Form C-103
Revised July 18, 2013

T-BIRD 30 STATE NO. 001

NOI TO PERMANENTLY ABANDON THIS WELL VIA CEMENT PLUGGING.

Operator: OXY USA WTP LIMITED PARTNERSHIP P.O. Box 4294 Houston, TX 772104294	OGRID: 192463
	Action Number: 390289
	Action Type: [C-103] NOI Plug & Abandon (C-103F)

Current Wellbore
T-BIRD 30 STATE NO. 001

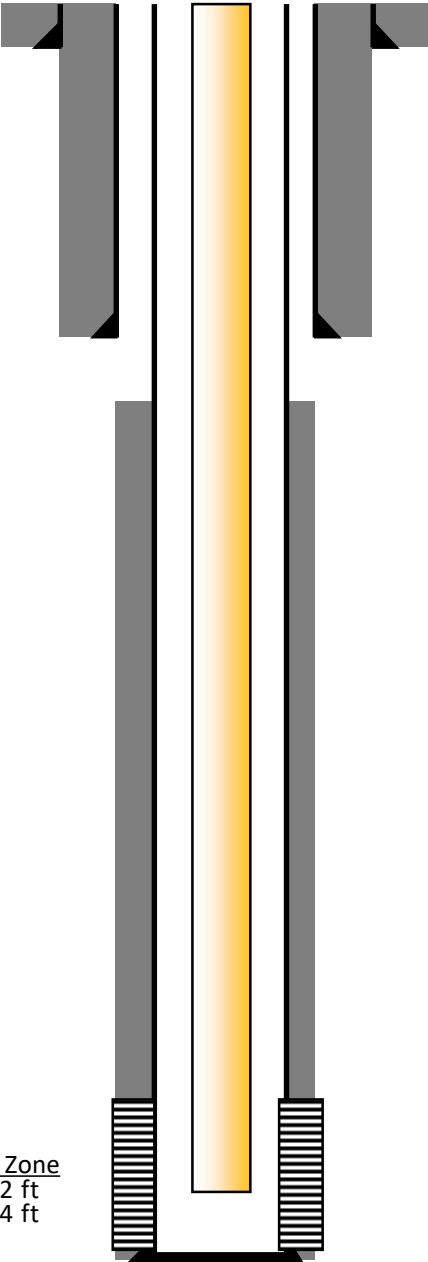
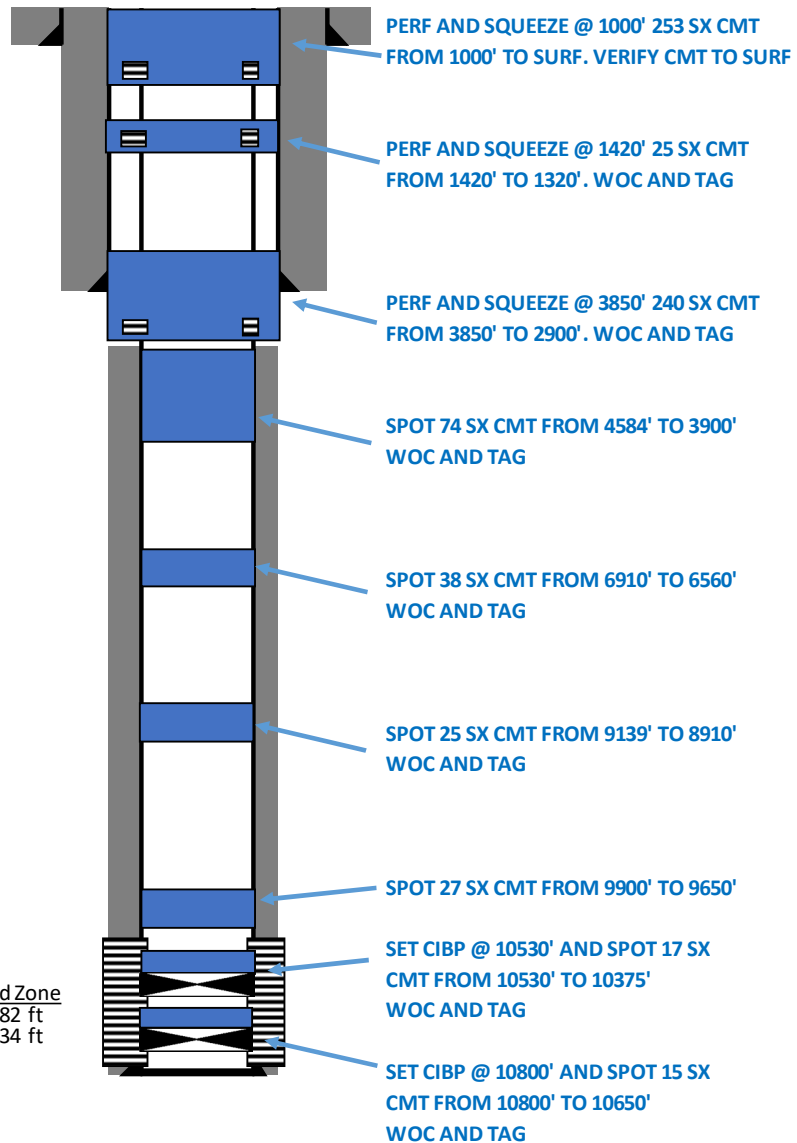
THIS IS A REFILEING PA NOI WITH UPDATED DOCUMENTS TO REFLECT THE CORRECTED PERFORATION DEPTHS. THE WELL WAS COMPLETED IN THE ATOKA AND MORROW, AND NO OTHER PERFORATIONS WERE ADDED.

Created By	Condition	Condition Date
gcordero	CBL must be submitted to OCD via OCD Permitting prior to submitting C-103P	10/8/2024
